Eagle Ranch Association
Regular Meeting
Design Review Board

Thursday, May 16, 2024
3:00 p.m. MDT

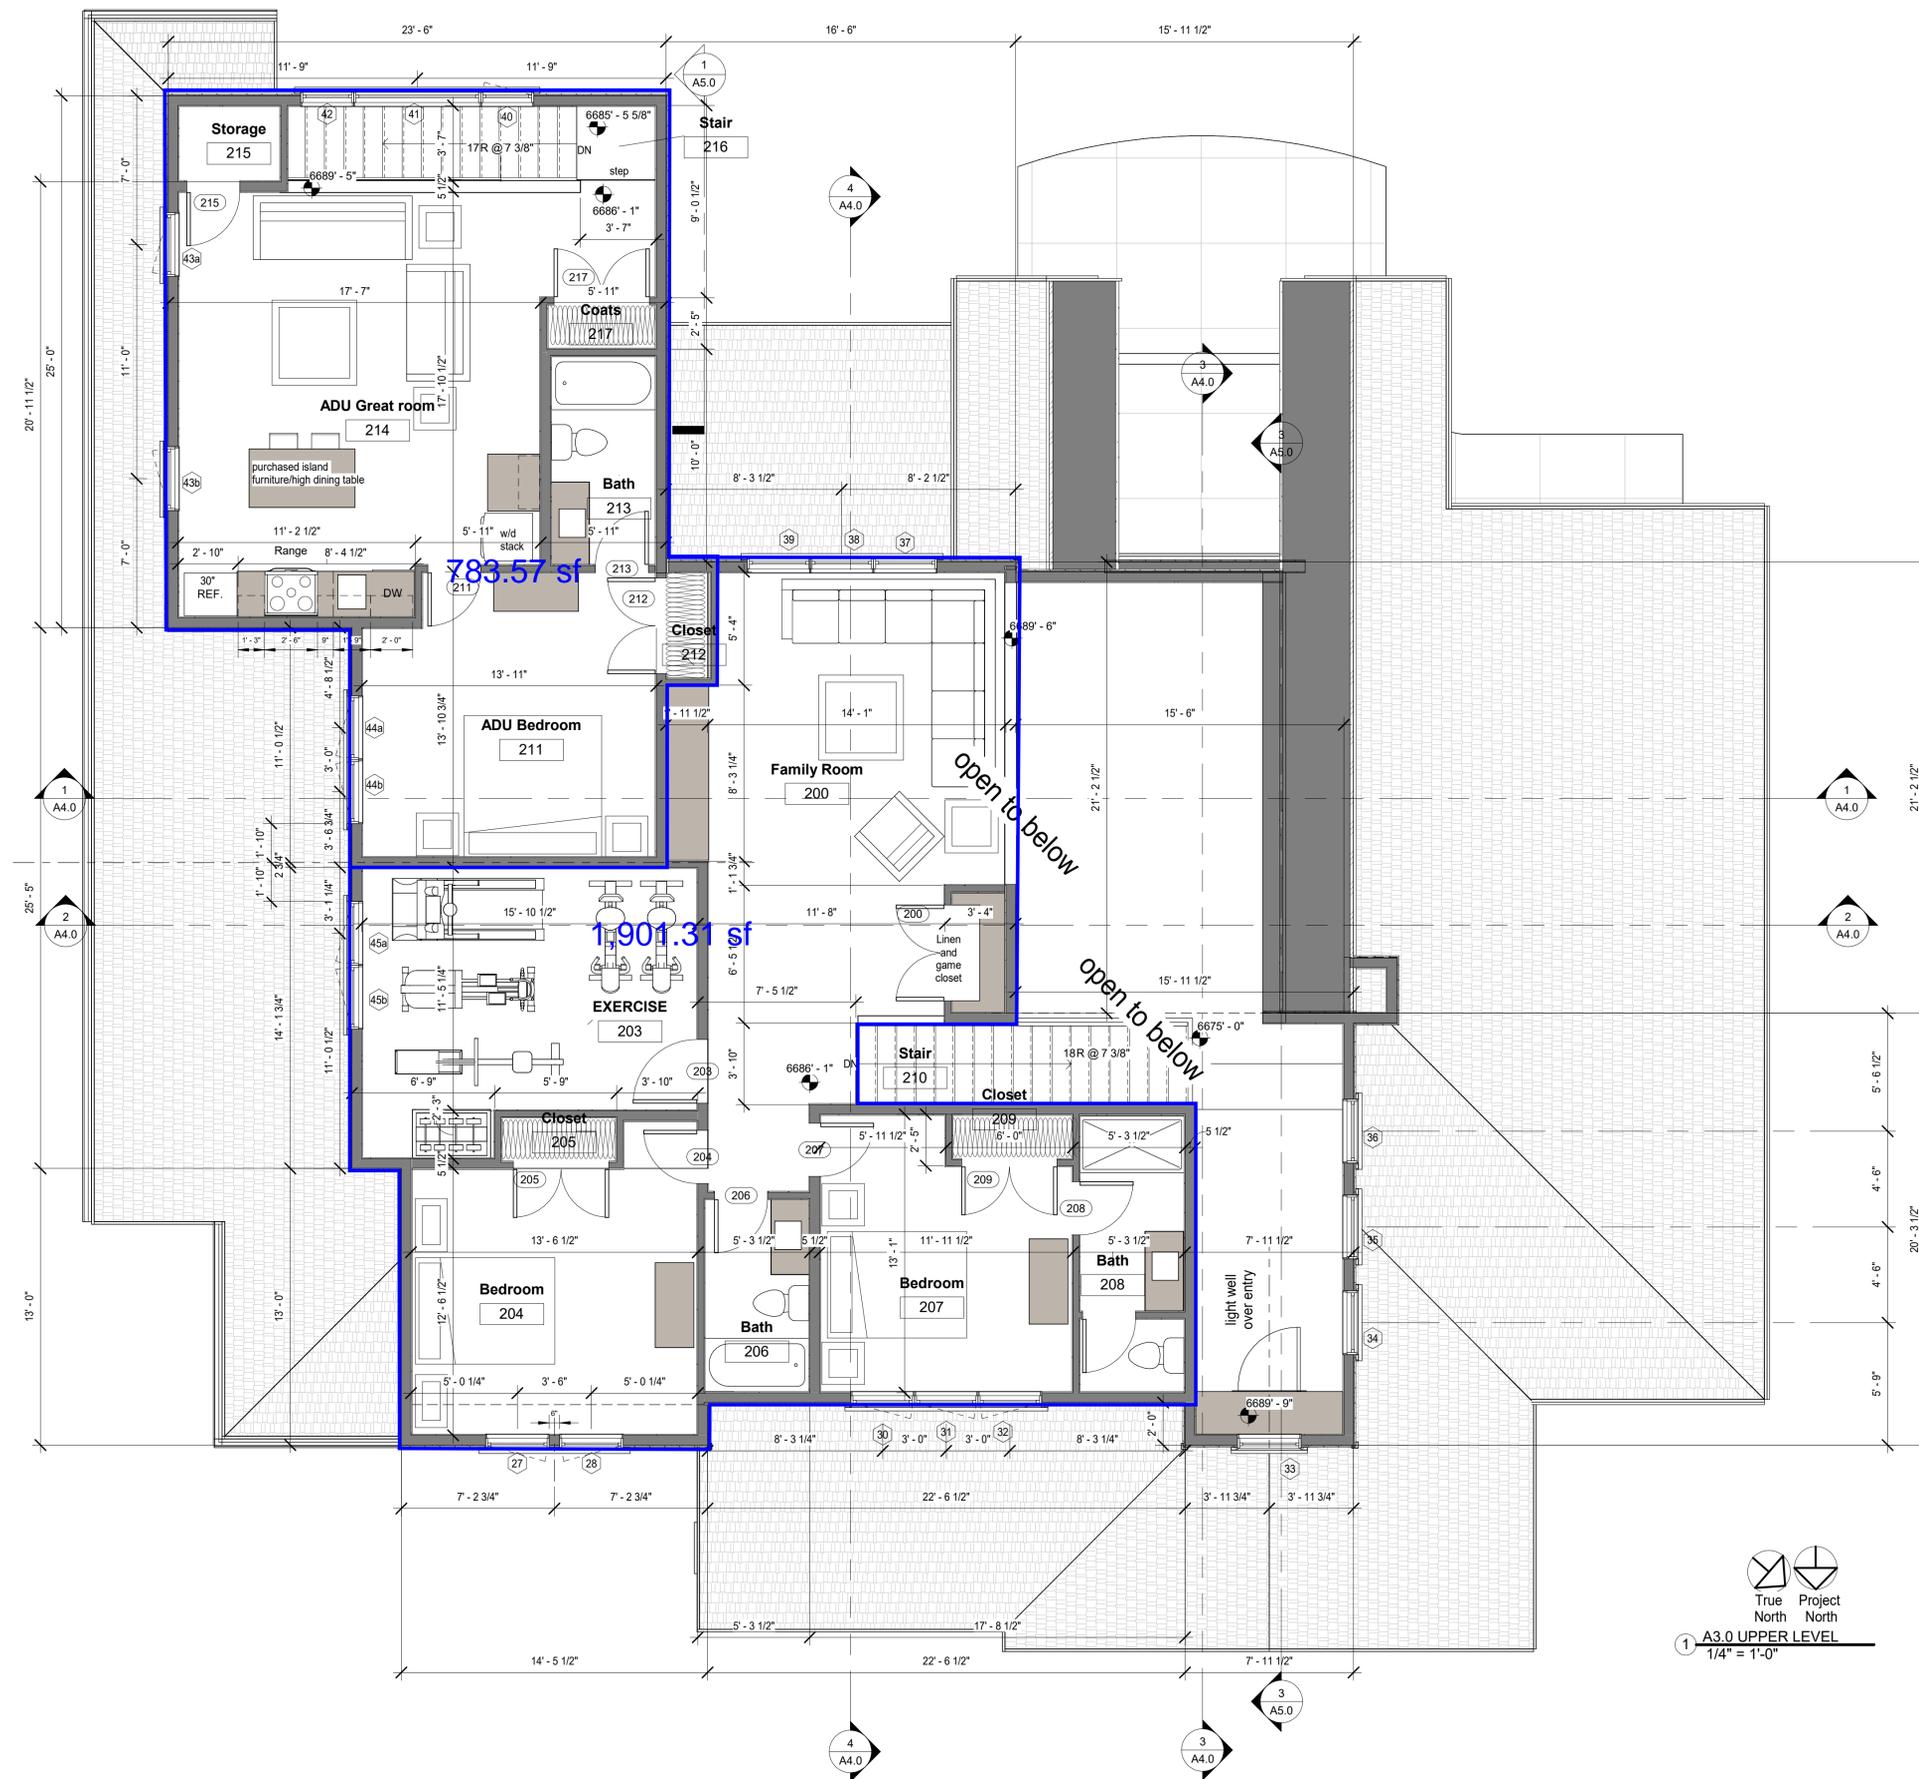
NEW SINGLE FAMILY
HOUSER RESIDENCE
 53 Seven Hermits
 Eagle Ranch, Eagle Colorado
 PRELIMINARY PLAN REVIEW

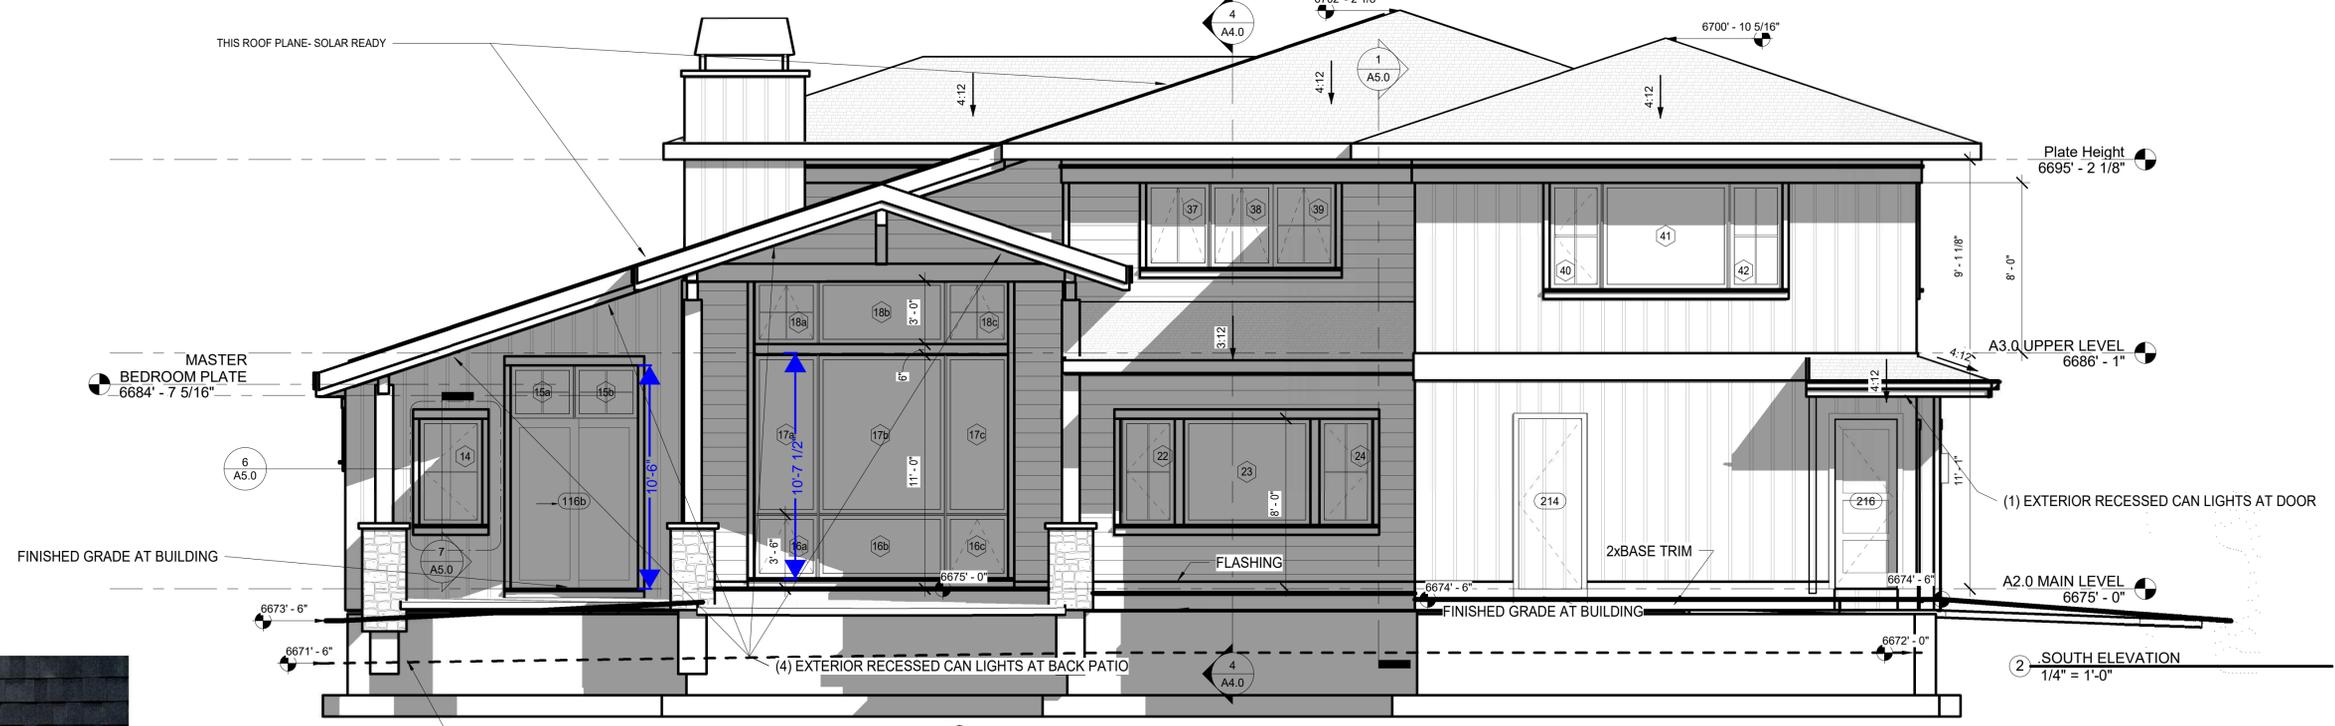
NEW SINGLE FAMILY
HOUSER RESIDENCE
 53 Seven Hermits
 Eagle Ranch, Eagle Colorado
 PRELIMINARY PLAN REVIEW
